TWR-K40X256 Tower Module

Hardware Errata and Changes

Rev. 0

TWRK40X256_01 JTAG TMS Pull-up Resistor

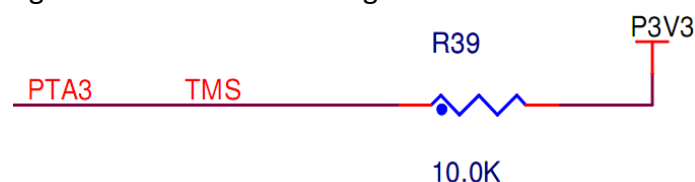
The pull-up resistor on the TMS signal is too strong and doesn't follow the JTAG standard.

Replace R39 with a 10K resistor.

The value of R39 was changed to 10.0K ohms starting with revision C of the schematics.

TWRK40X256_02 Lack of Reset Output

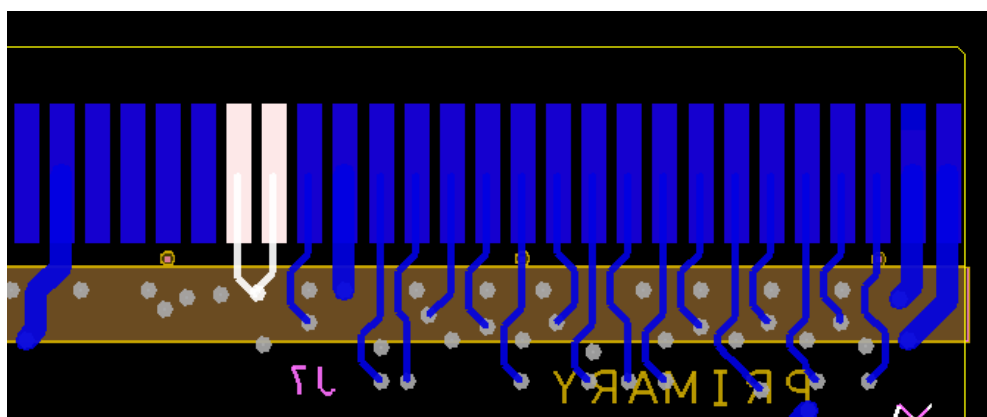
The RSTOUT pin on the Elevator Primary Connector (A63) is connected to the RSTIN pin (A62) which is connected to RESET_B on the MCU. There is no way for the MCU to control the RESET_B pin in GPIO mode so that it can drive RSTOUT to other Tower Peripheral Modules. Some ICs on Tower Peripheral Modules need to be independently reset as part of their initialization sequence (e.g. the LCD controller on the TWR-LCD).

There is no easily implemented workaround for this erratum. It is possible to cut the trace connecting RSTOUT (bottom side of PCB, shown as the highlighted pin on the right in the figure below) to RSTIN and solder a wire from the pad to an available GPIO pin from the K40 MCU. Care must be taken when soldering to the pad not to interfere with the ability to plug the card into a TWR-ELEV board.

PTE27 is used to drive RSTOUT on revision C of the schematics. However, PTE27 is also used as the GPIO7/SD_WP_DET signal—pin A11 on the Primary Elevator. This introduces possible interference with SD Cards and peripheral modules that utilize GPIO7. See *TWRK40X256_04 GPIO7/PTE27 and RSTOUT Interference*.
